Appl. No.09/942,628
Amdt. dated June 21, 2005
Reply to Office action of March 22, 2005
Atty. Docket No. AP1102US

Amendments to the Drawings:

REMARKS/ARGUMENTS

FIG. 4

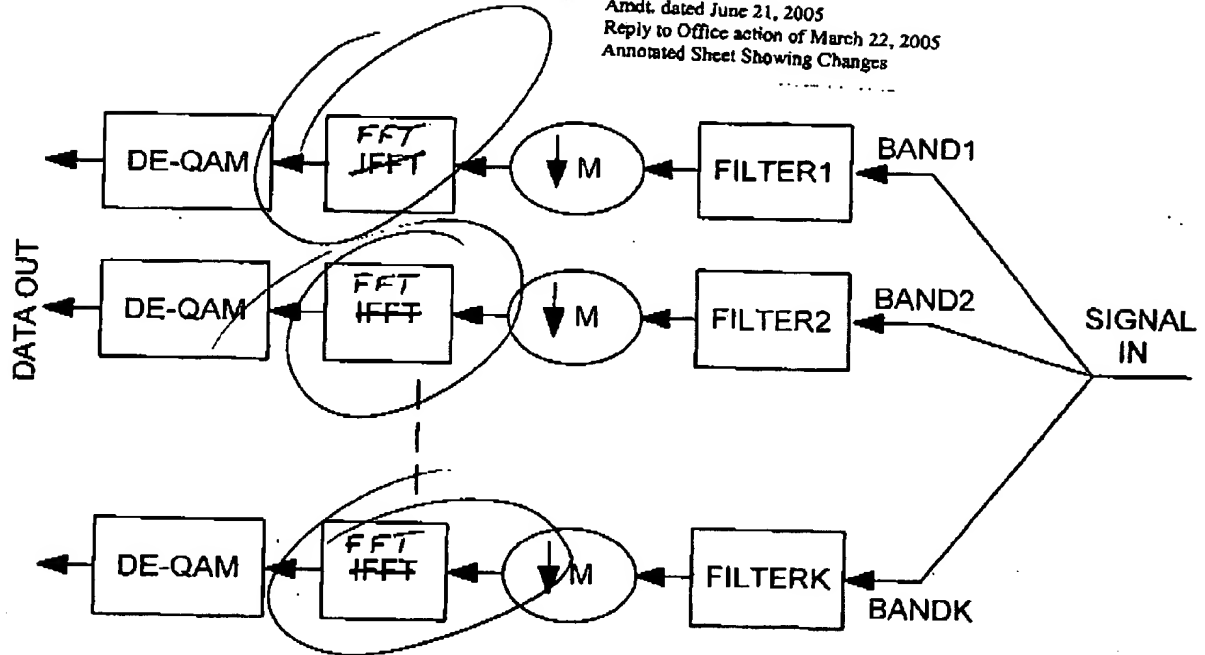
The replacement sheets of drawings include changes to Figures 4, 6 and 7. These sheets, which include Figures 4, 5, 6, 7 and 8, replace the original sheets which included Figures 4, 5, 6, 7 and 8. In amended Figure 4, the three occurrences of "FFT" have been changed to "IFFT". In amended Figure 6, the three occurrences of "IFFT" have been changed to "FFT".

The amendments to the drawings correct the labelling of the FFT and IFFT units which had been transposed in original Figures 4 and 7.
